Addendum

Iowa Department of Transportation

Date of Addendum: August 11, 2015

B.O.	Proposal ID	Proposal Work Type	County	Project Number	Addendum
303	78-0801-366	GRADING	POTTAWATTAMIE	IMN-029-3(127)480E-78 IMN-080-1(366)40E-78	18AUG303.A02

Replace plan sheet M.6, M.7, & M.8 with the attached:

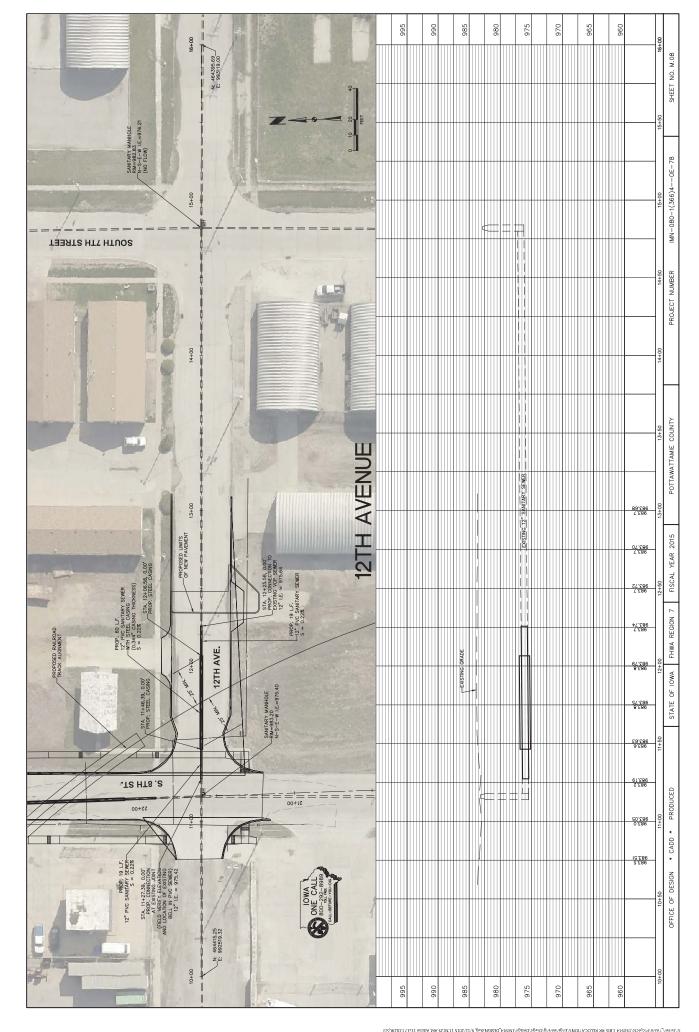
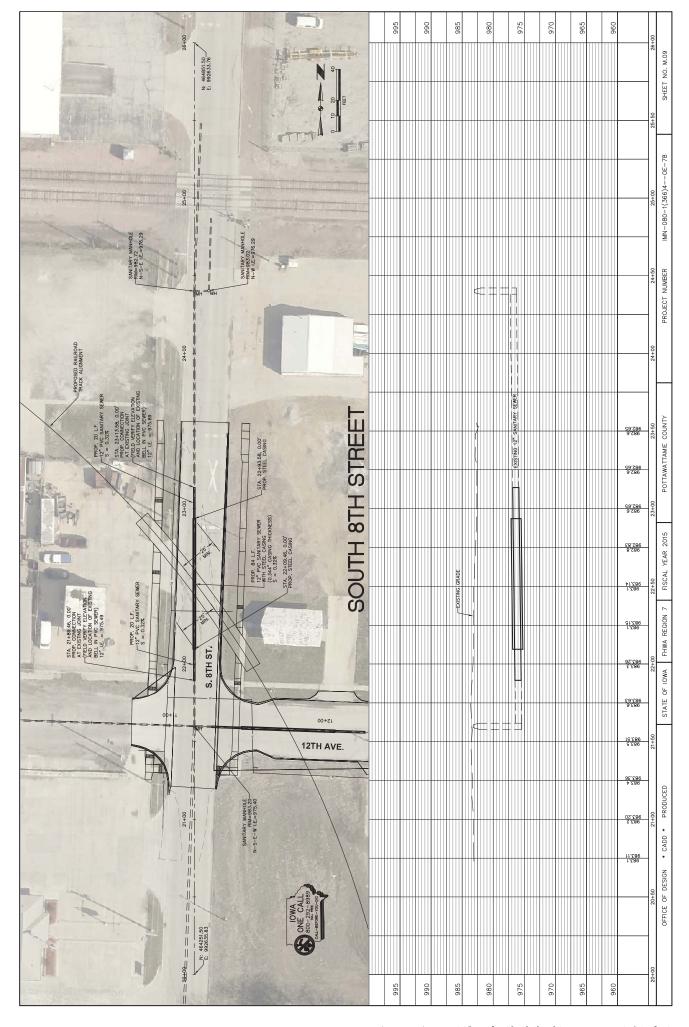
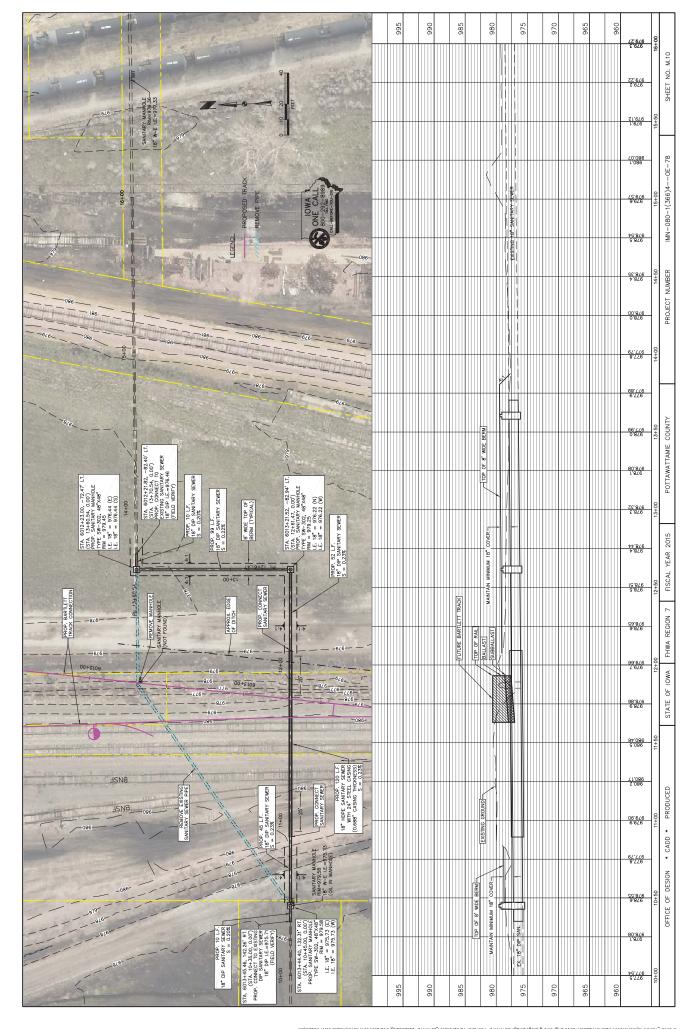
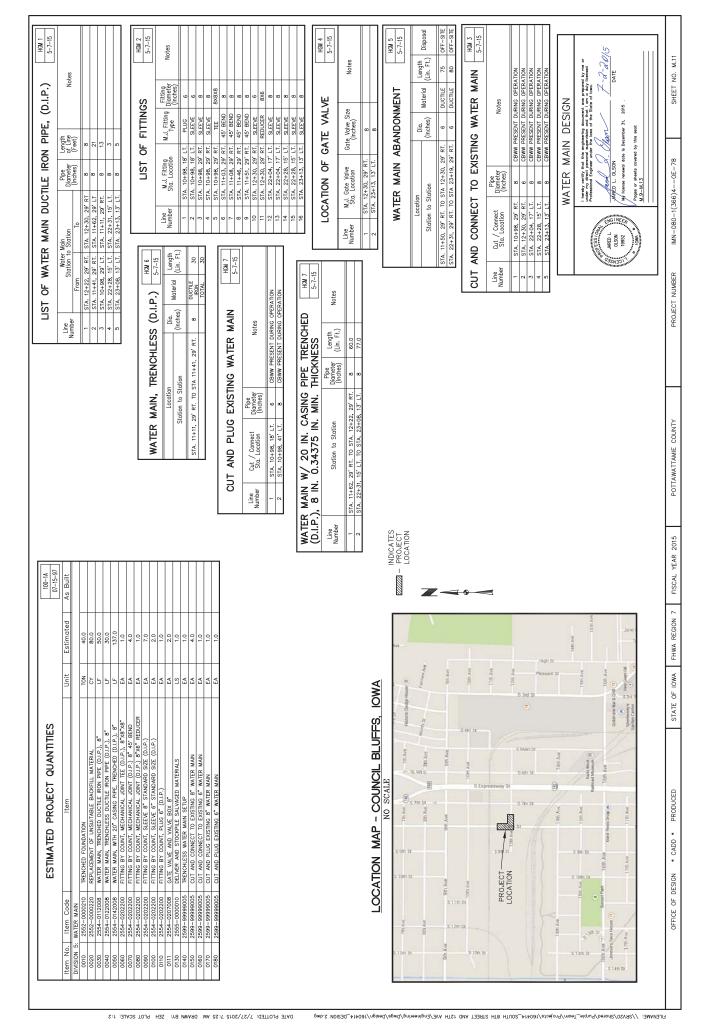
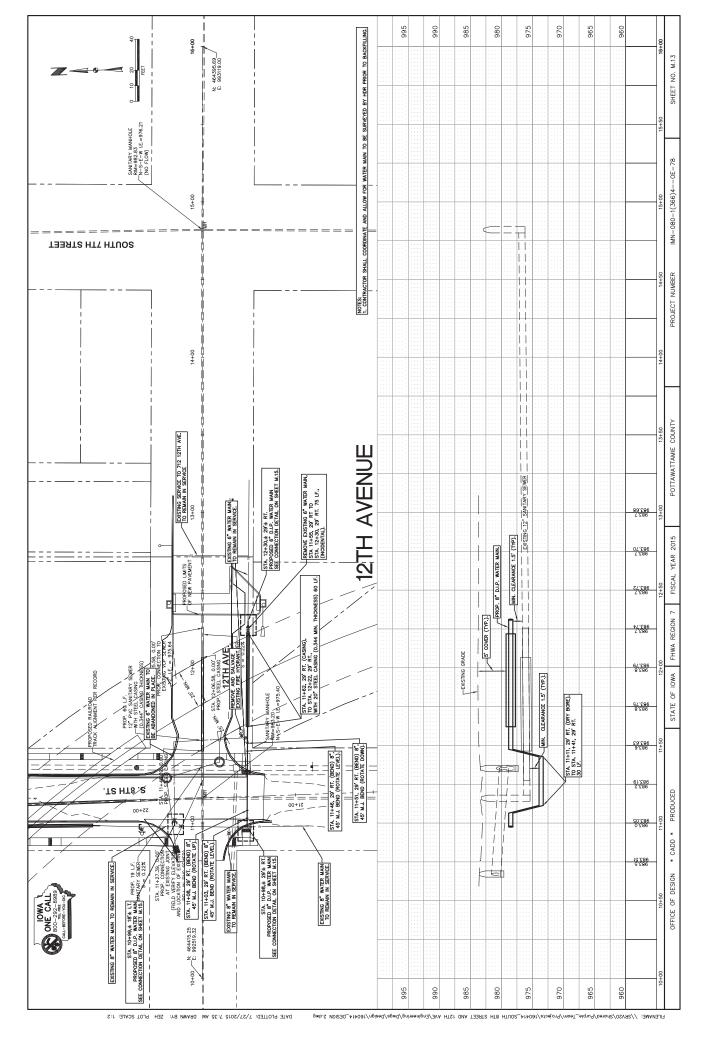
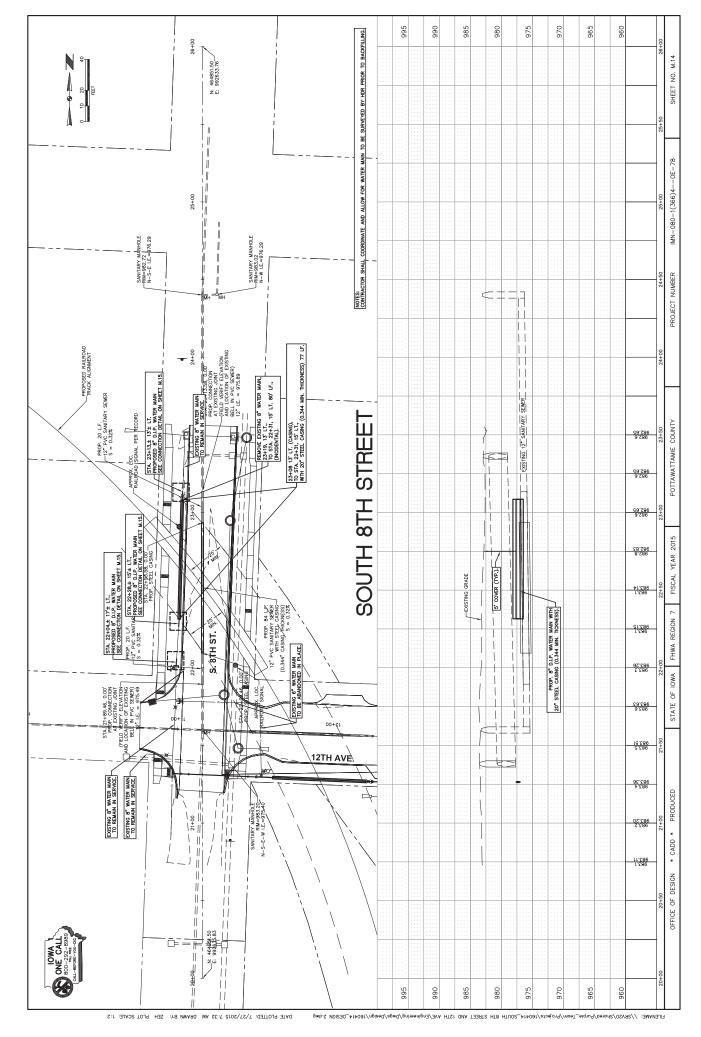
Add plan sheets M.9 thru M.15 to the plans:

Additional plan sheets M.6-M.10 and M.11-M15 for sanitary sewer relocation at 20^{th} Avenue and water main relocation in the area of 8^{th} Street and 12^{th} Avenue.
